Interactive comment on “Technical Note: A fully automated purge and trap-GC-MS system for quantification of volatile organic compound (VOC) fluxes between the ocean and atmosphere” by S. J. Andrews et al.

S. J. Andrews et al.

Received and published: 13 March 2015

Fig. 1.

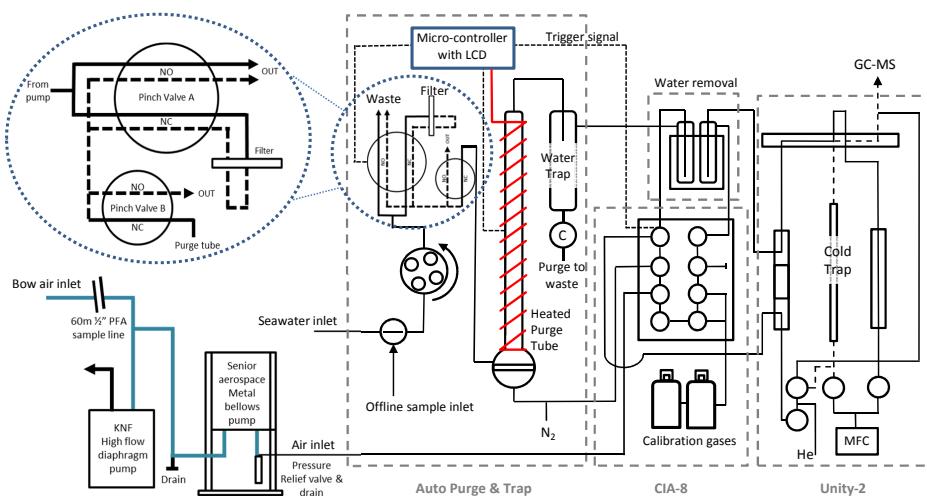
and its performance characteristics are well documented and it appears that this is a system that, despite its size and complexity, (large GC-MS and inlet system) is readily able to go to sea, as the authors report that it has collected good quality data on 6 cruises. I think it is a nice contribution to the body of literature on sea-going purge and trap systems and the total number of analytes captured is also impressive. It would be valuable to build large data sets of these VOC fluxes over the ocean. I have only one major concern that I would like the authors to clarify, and a few minor comments about the text. The paper concerns itself primarily with describing the PT system and extraction of gases from seawater. However, the title refers to VOC fluxes, and in the last figure (Figure 6) indeed we see air-side concentrations of two VOCs. What is not clear, is whether these air-side measurements were made with the same system or whether they require a different system altogether. I see no part of the diagram in Figure 1 where air is inlet to the system for GC-MS analysis and no discussion of air sampling to avoid VOC contamination from shipboard activities. Do you have to trap and preconcentrate air samples for GC-MS analysis of these VOCs? If the air-side samples were collected with the same system, this should be indicated in Figure 1 and in the text with adequate description of how that was done. If those measurements require a separate method/apparatus that is not part of this system, then the authors should make that clear in the text, in Figure 6.

Response 1 from authors: We agree that this was an oversight. We have modified Fig. 1 (below) to show how air samples were processed. We have also added text to the end of section 2.2 to describe how air samples were collected by the instrument between each water sample

Authors changes to manuscript in response to referee: "In order to calculate ocean-atmospheric fluxes, air samples were acquired between each water sample. Air was drawn from a bow inlet through 1/2" PFA tubing at approx. 35 L min⁻¹ using a diaphragm pump (KNF, N035.1.2AN.18). Before the air reached this pump it was drawn through a clean stainless steel bellows pump (Senior Aerospace, MB-158) and pres-

surised into the thermal desorption unit at 10 psi with the majority of flow vented via a proportional relief valve." In section 2.1 we will add "As for direct air analysis, the gas sample is pre-concentrated..." to confirm that the same instrumental method was used for both air and water samples.
